Project Name: Village At Mill Pond - Master Plan Design Criteria Amendments

Project Description: Amendments to the Design Criteria for the Village At Mill Pond - Master Plan.
See attachment for proposed amendments.

The Village At Mill Pond Design Guidelines - Explanations

**EXTERIOR
COLUMN &
RAILING TYPES**

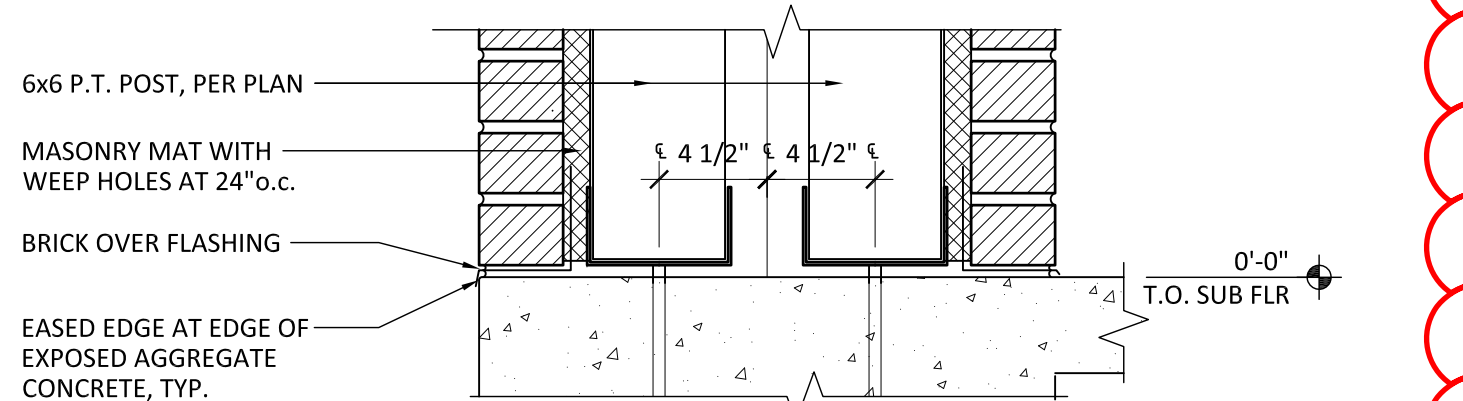
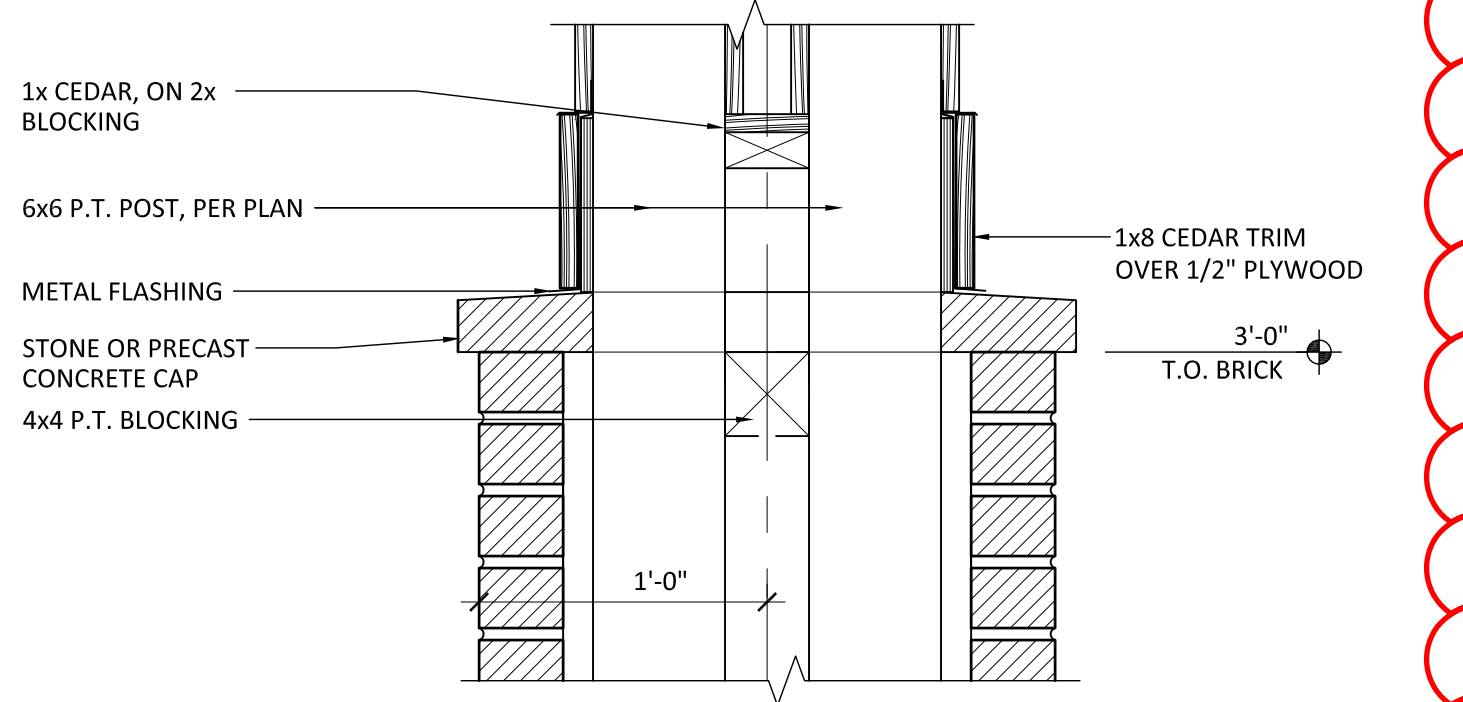
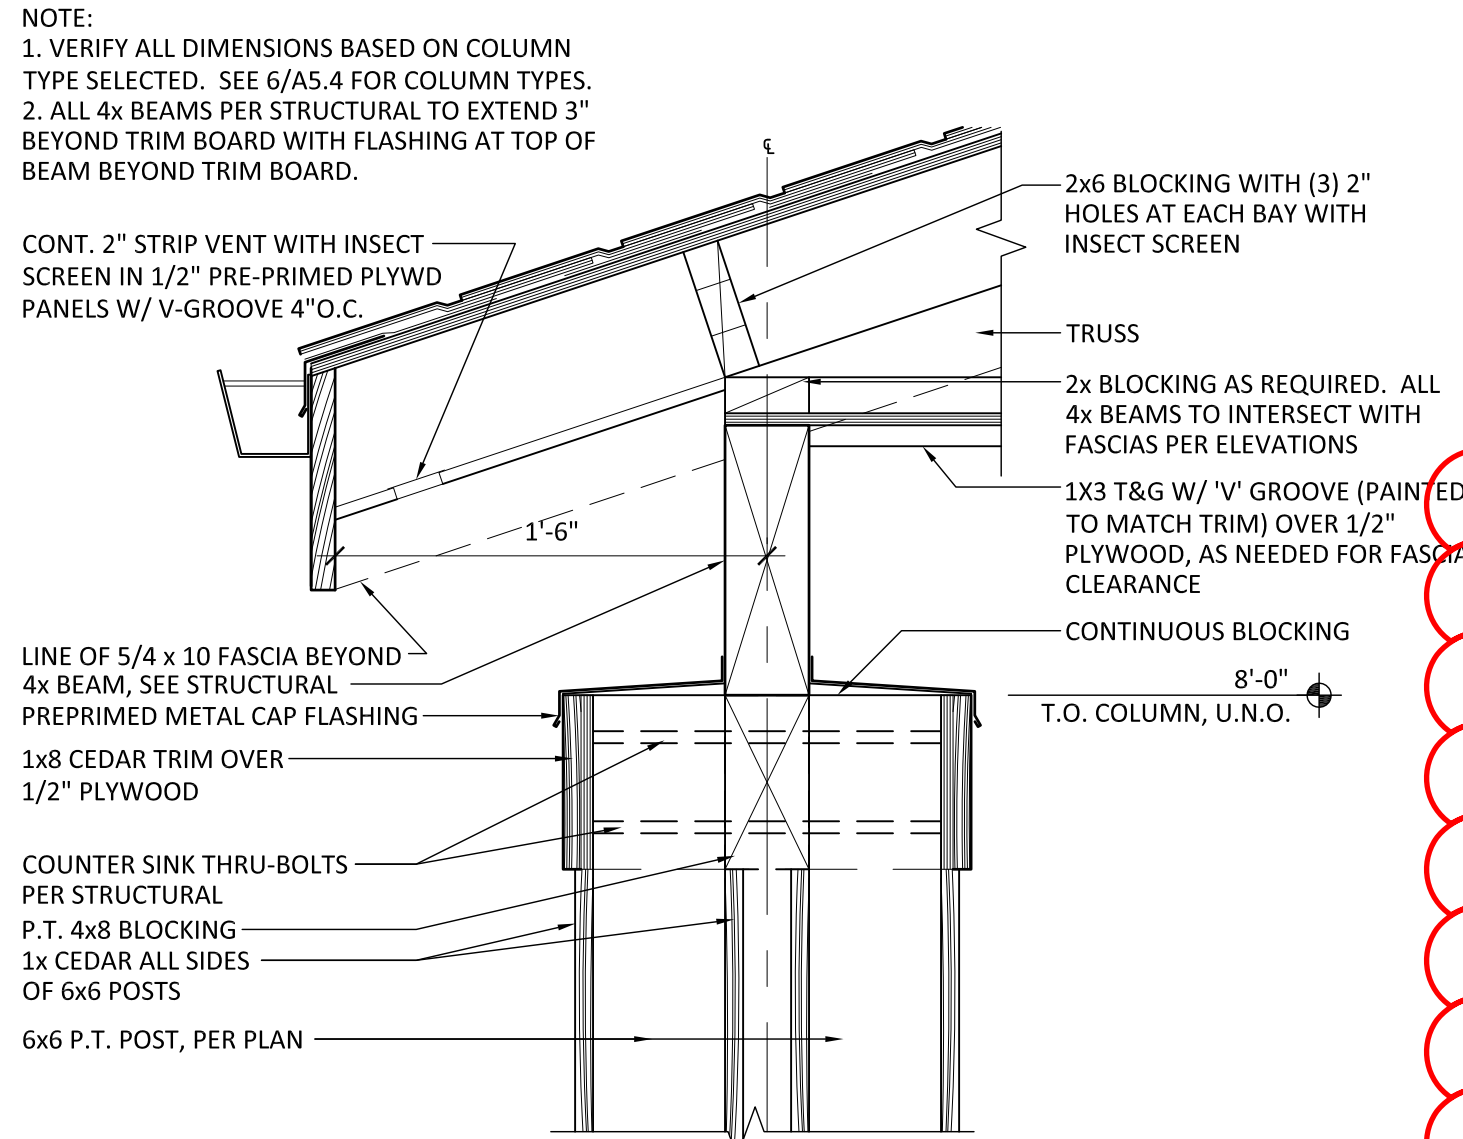
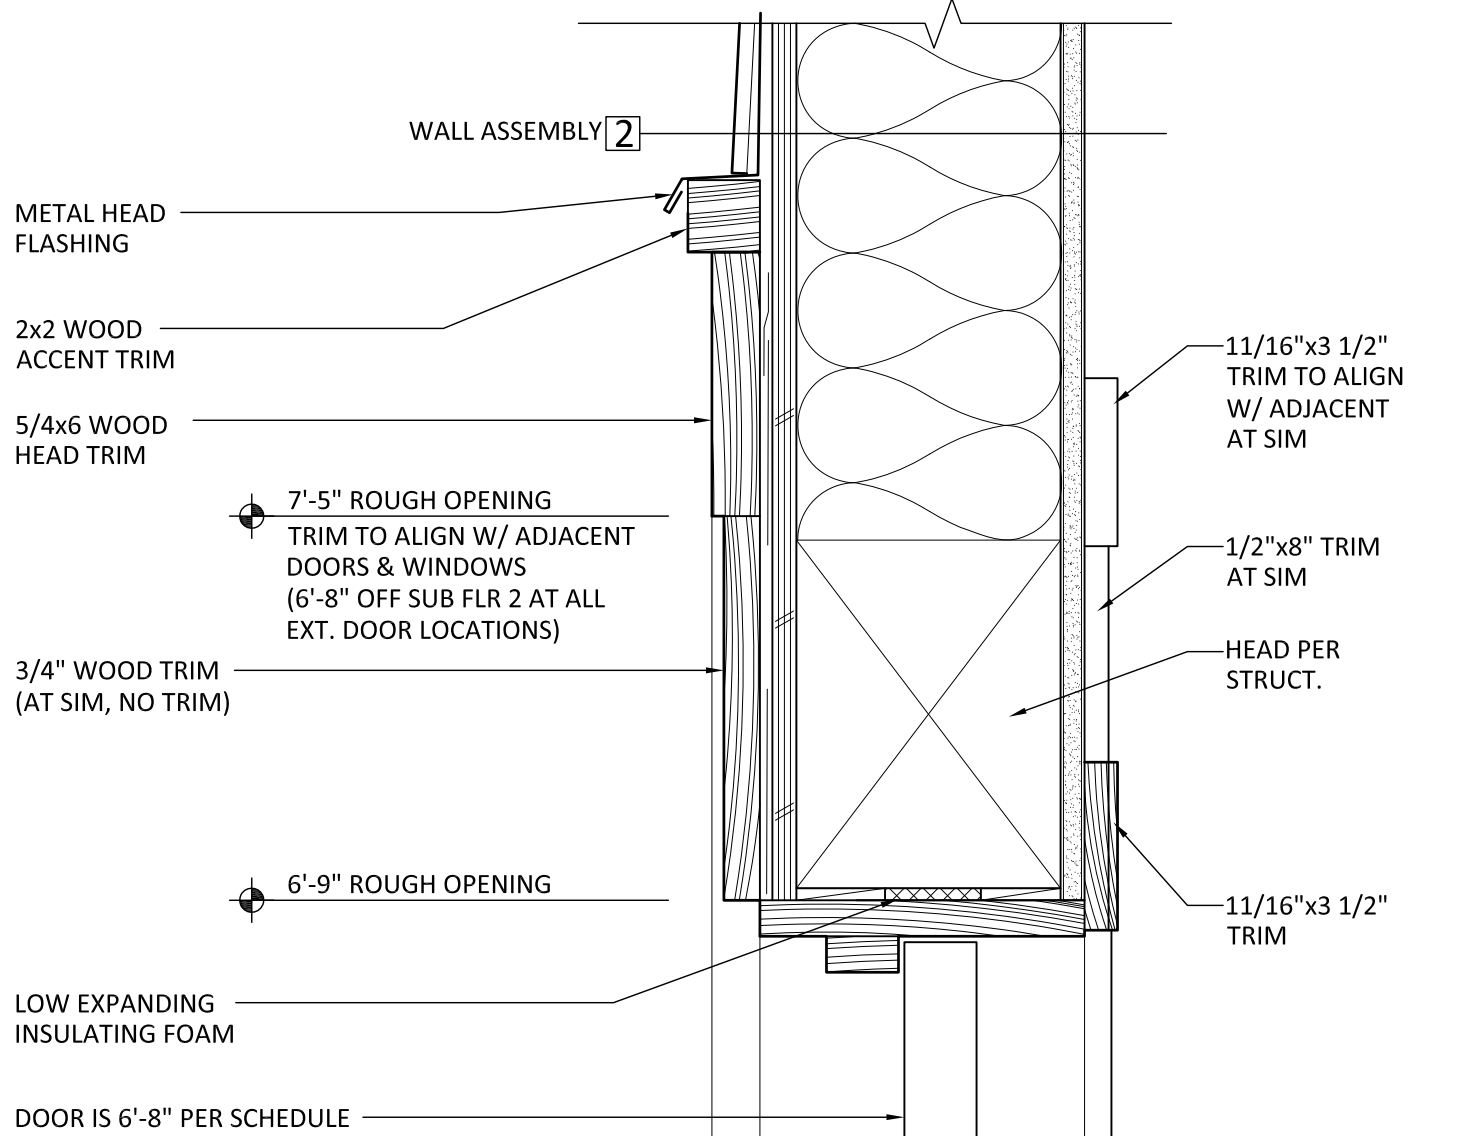
- Each model will have ~~at least 2 different massing solutions and~~ a variety of color schemes.

See Attachment 3-A for List Column Type and Railing Type Varieties

MATERIALS RETURN AT LEAST 24" ALONG EACH SIDE OF THE HOUSE

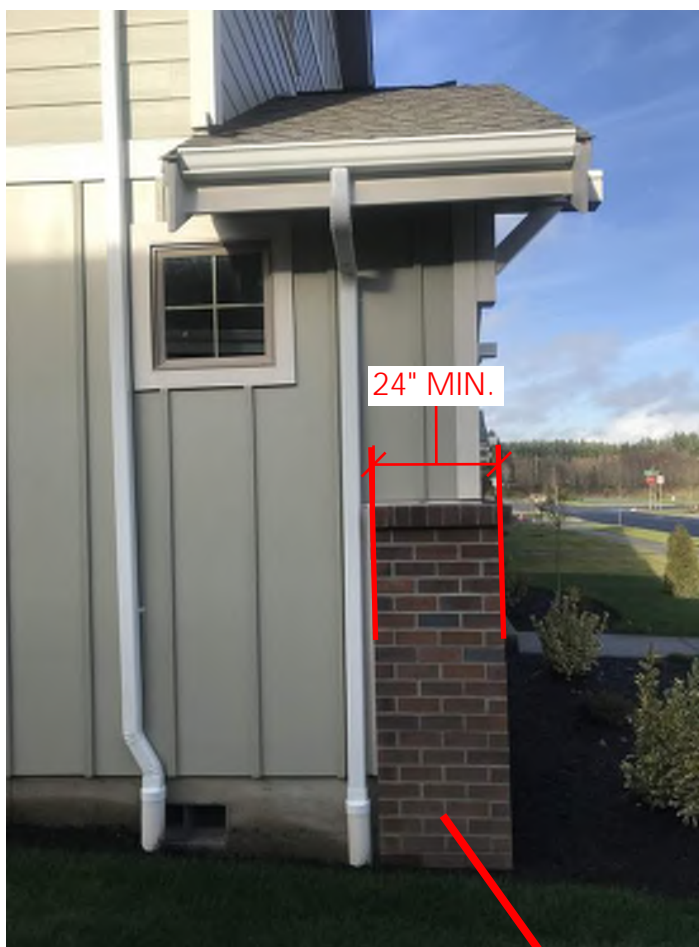
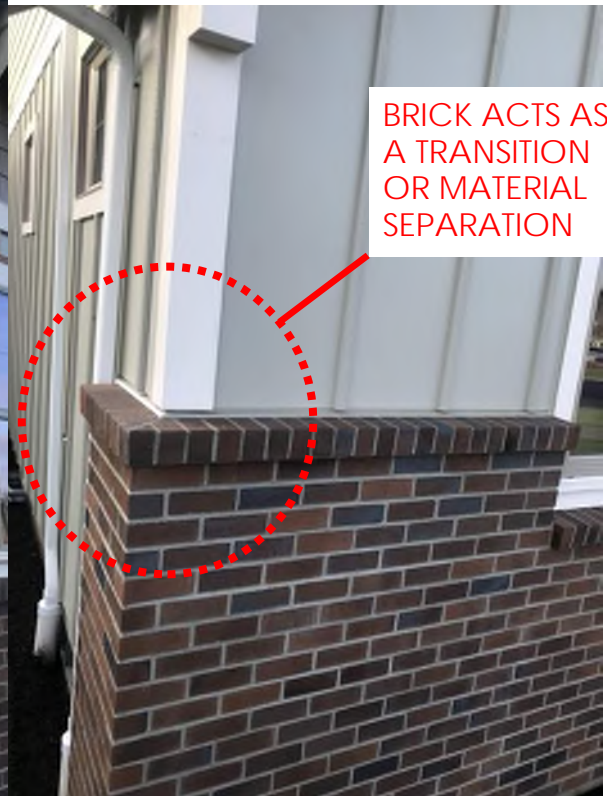
- Any vertical changes in materials in a vertical wall, such as from brick to wood, shall wrap the corners no less than 24 inches. ~~The material change shall occur at an internal corner or a logical transition such as aligning with a window edge or chimney.~~

Brick & stone are materials that further enhance the appearance of the home, their nature and thickness allow them to act as a transition piece without the need for trim board. The 2-3 inches in material thickness provide a variety in depth and provide a break in the surface plane of the exterior elevation eliminating the need for a material change trim board.

PAINTED FIBERGLASS DOOR

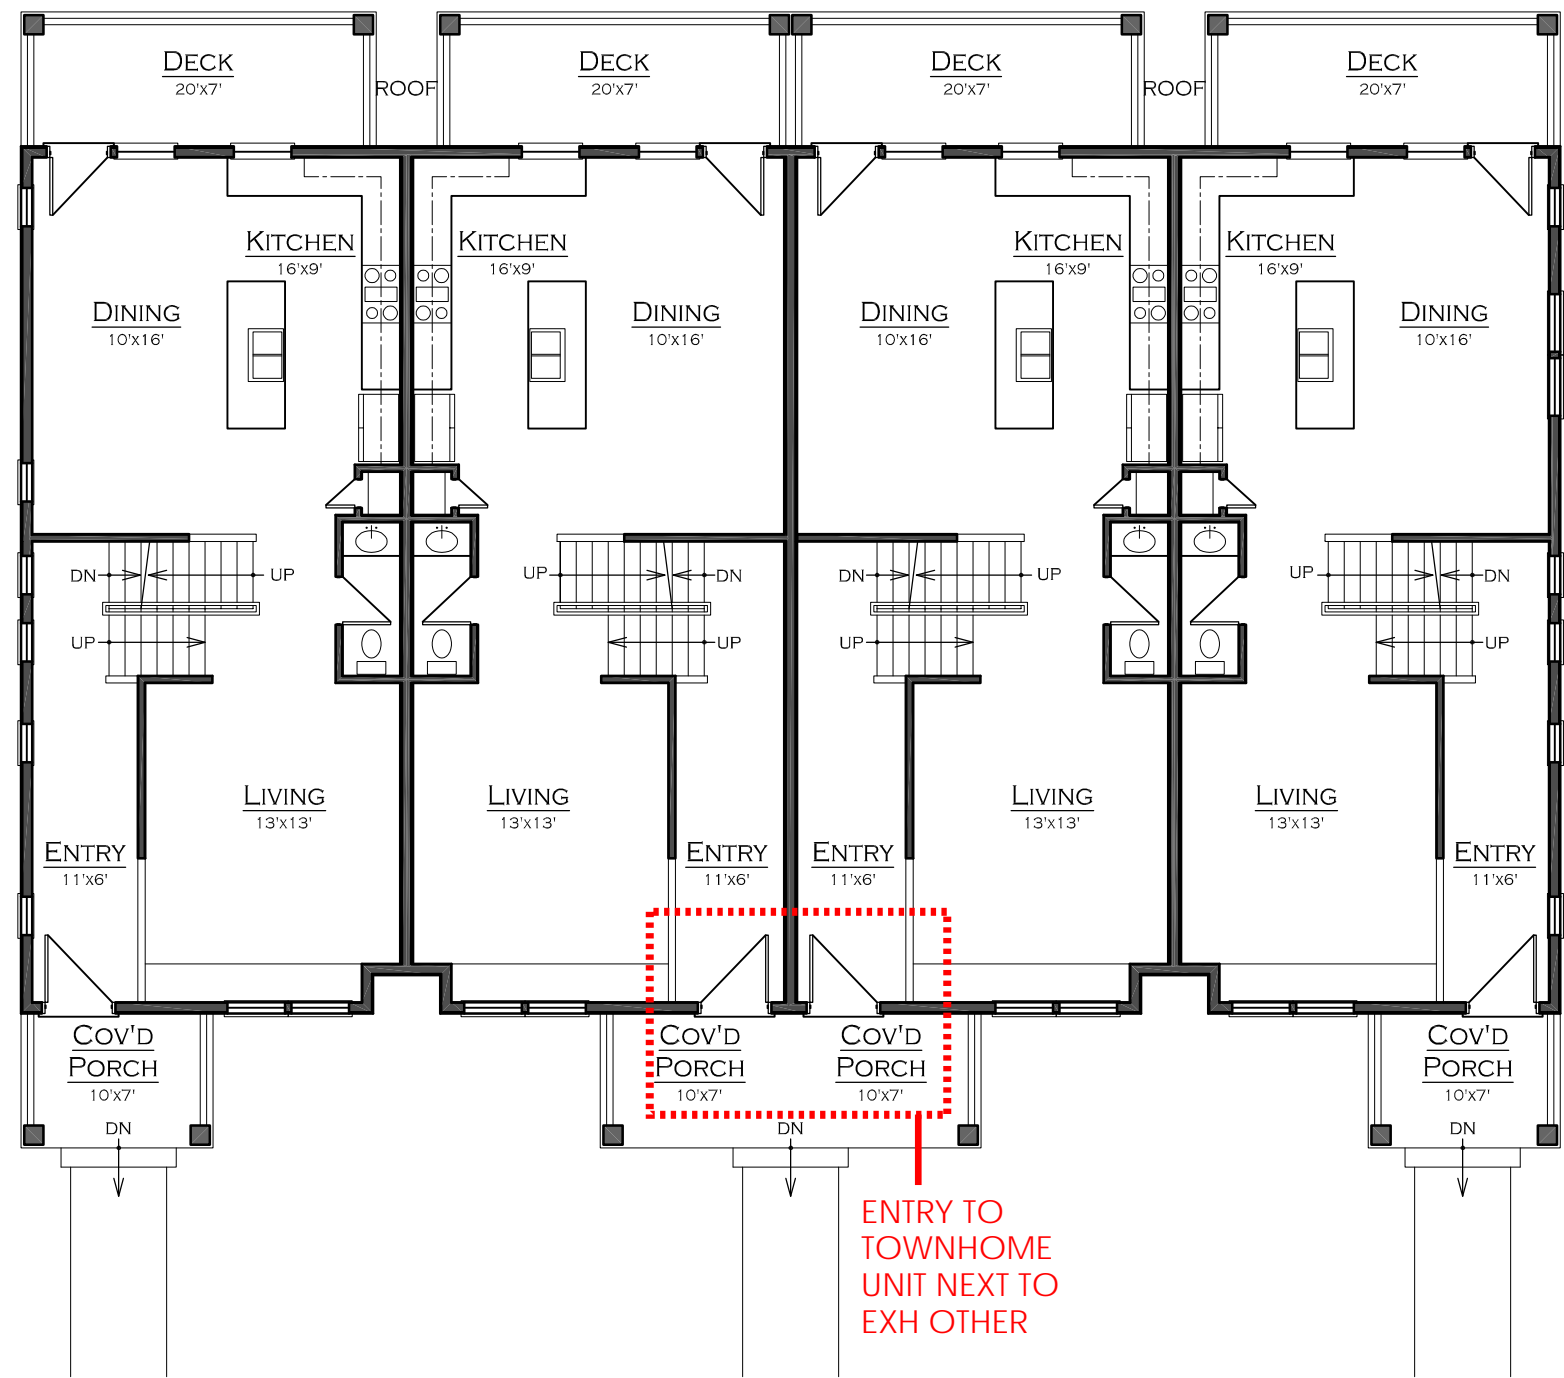
- Front doors shall be made of vertical grain fir (finished to allow natural wood to show) **or insulated fiberglass with a wood texture and painted finish;** all other doors shall be made of wood, insulated fiberglass, or insulated metal.

-Painted fiberglass doors add to variety and color within the development.

-Fiberglass doors provide a similar look and appearance to wood doors.

PICTURE IS SHOWING SHADE AND SHADOW DETAIL CREATED BY VARIATION

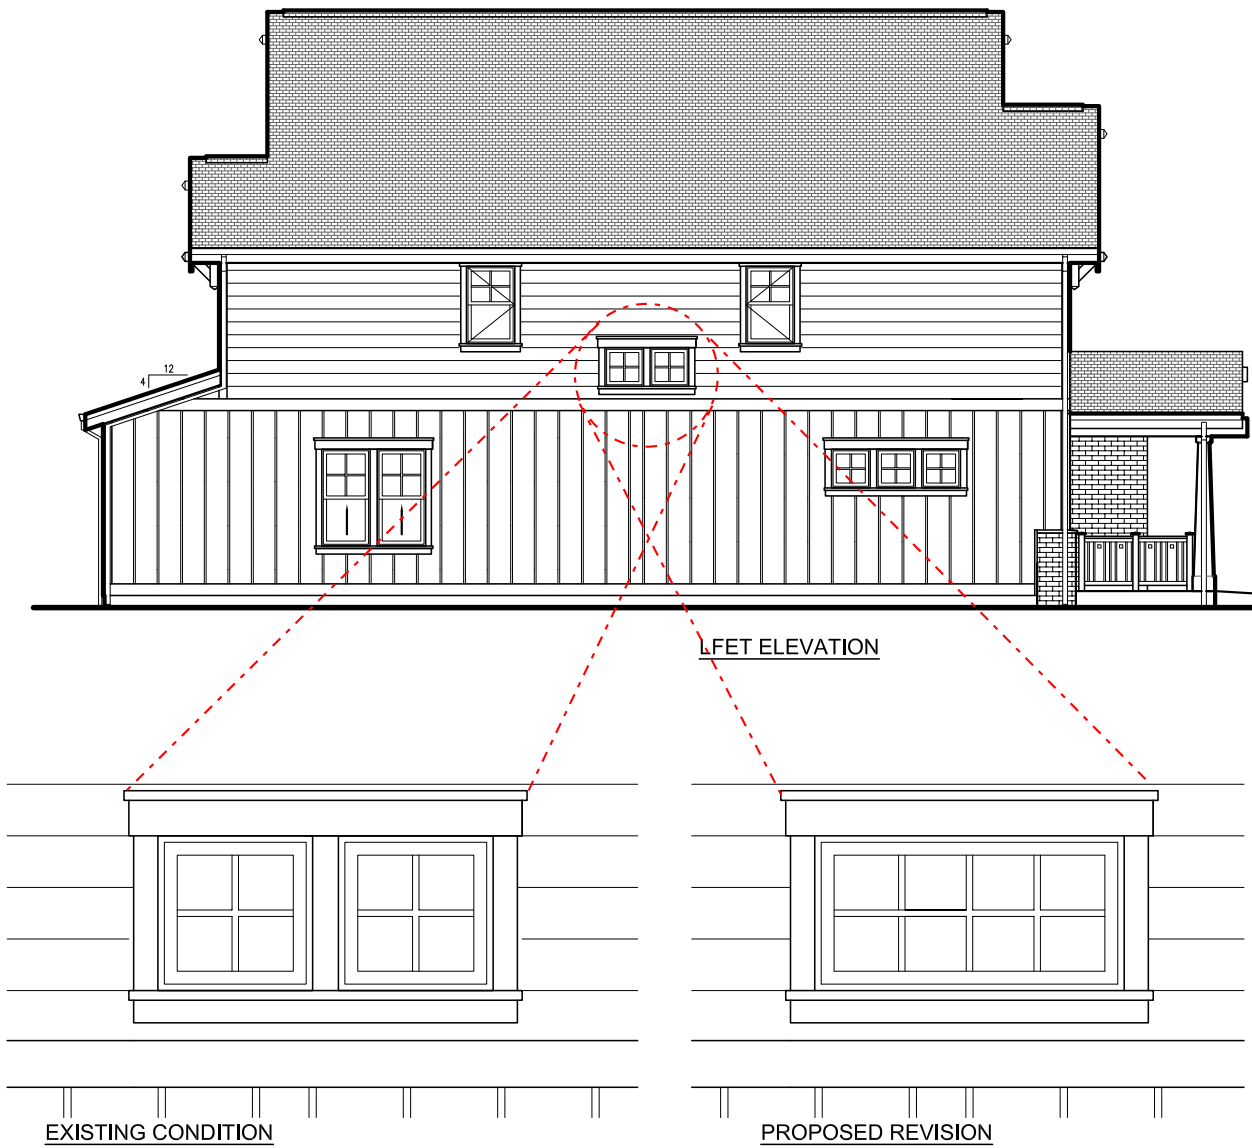
- *Provide relief, detail, and variation on the façade ~~by utilizing well proportioned openings that are designed to create shade and shadow detail.~~*

- The term 'well proportioned' is subjective in nature and needs to be removed for clarity.
- Shade and shadow detail is achieved by the requirement to utilize different materials on the elevation that provide relief in the plane depth and create shadow lines.
-See attachment 12-A Window Trim for example of how this criteria is addressed.
- The terms: relief, detail, and variation address what the second part of the design criteria is indicating and should be removed to eliminate confusion and redundancy.
- Overall window proportions are address in a separate criteria (see amendment #11).
